**ERRATA – EXPERTS MISSION TO REVIEW THE
PSAR OF THE RRR FOR ARPANSA**

**REGULATORY BRANCH, ARPANSA
26 July 2001**

Figure 1 – Comparison between design value and disaggregated IGNS value.

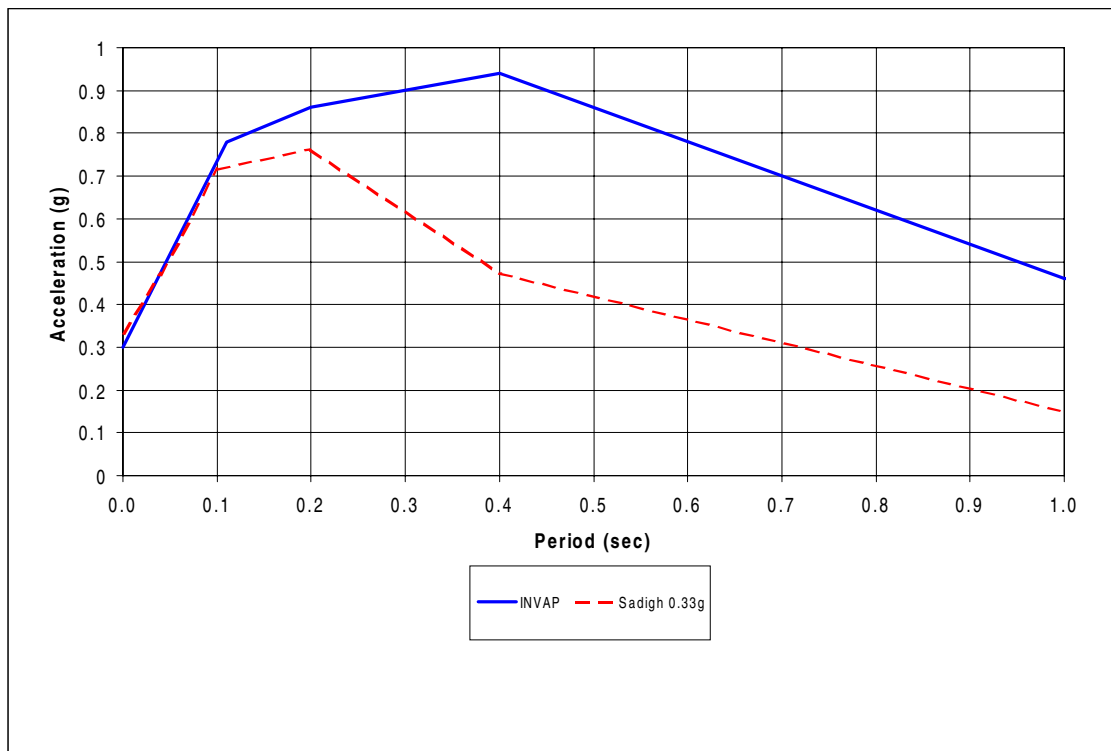
Figures 1 and 2 provided by ANSTO and included in Appendix V - Issue Number 2 are inaccurate. ANSTO have requested that the corrected figures be included in the report. The corrected figures were provided on 17 July 2001.

The inaccuracy of the figures relates to the failure of the graphs depicted in Appendix V – Issue Number 2 to meet the y-axis at 0.3g. All other values have remained the same.
